Response to Change Request ALMA-40.00.00.00-200 on Band 6 IF Frequencies

Date submitted: 2009-08-07
Revised 2009-09-15
CRE #: ALMA-40.00.00.00-200-A-CRE

TITLE: Change the Band 6 Receiver Output IF range in the ALMA Front End Specifications Document

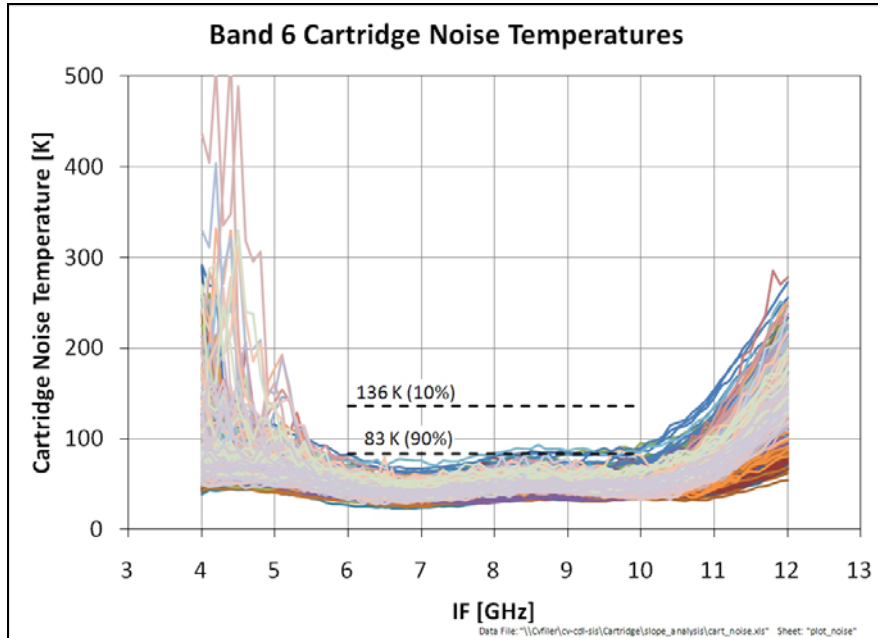
Turning to the excess LO noise, this seems to be a different class of problem. From the noise temperature plot, Fig 1 of the CRE, it is clear that a small fraction of the WCA's are adding a great deal of excess noise at 4 to 5 GHz for some LO settings. Figures 3 and 4 show that, for that particular WCA at least, this problem is unfortunately worst at just the relevant LO frequency of 225GHz.

I would argue that WCA's with such a large amount of excess noise should not be accepted and that this should be done quite independent of issue raised in the CRE. There are at least three

Figure 2: Histogram showing the distribution of mixer-preamplifier pairs based on their noise performance over 6 – 10 GHz IF range, over 4-6 GHz IF range, and at 4.3 GHz and 5.0 GHz spot IF.

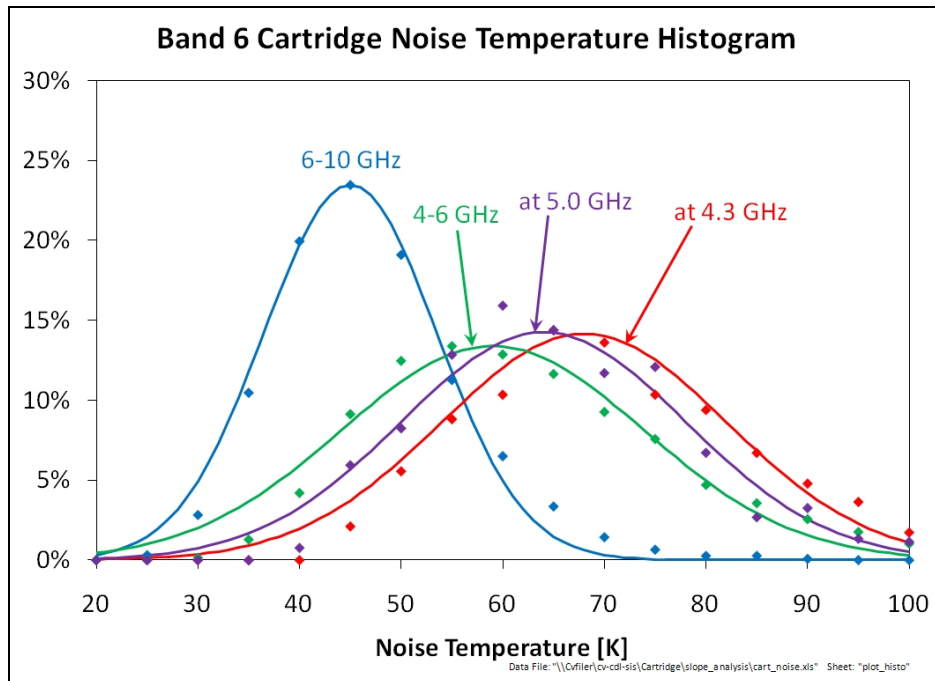
It appears from Figure 2 of the CRE that a small fraction of the mixer-preamps will fail this, but it is not stated whether the histogram is for all LO frequencies or just 225GHz, which is the relevant one here, and whether or not these plots include cases where there is excess LO noise. Going back to John Effland's memo, which is RD3 of the CRE, it appears that noise from the preamplifiers should not be a problem and there is no obvious reason why different SIS mixers would change the noise as a function of IF frequency much.

As far as the noise temperature is concerned, I suggest that the specification should be for an SSB receiver temperature (averaged over both sidebands) of 83K at an IF frequency of 5GHz and an LO frequency of 225GHz. (I think these frequencies are close enough to those required for the 12CO and 13CO rest frequencies of 230.54 and 220.40 and allow for some red-shift.)

Figure 5: Predicted cartridge gain for the best and worst mixer-preamps measured to date.

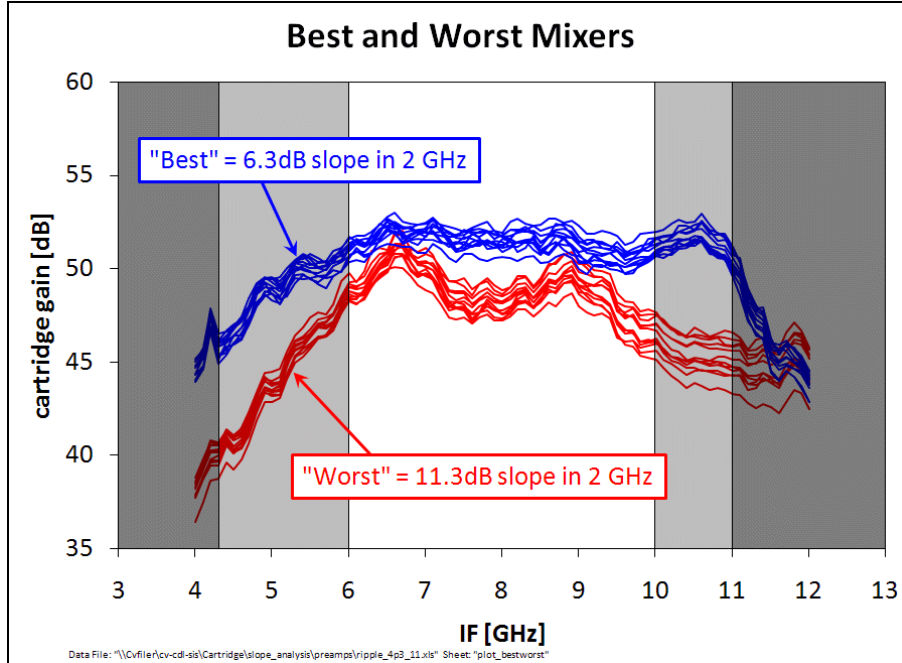
I suggest that the criterion on slope should be no more than 6dB more power at 6GHz than at 5GHz. I think that even the worst case shown in figure 5 of the CRE would meet this. If the band 6 people can accept a limit of 5dB so much the better. (We should try to check what the effects really are for these cases where there is a big slope right across the band and we are interested in a relatively narrow section in the middle.)
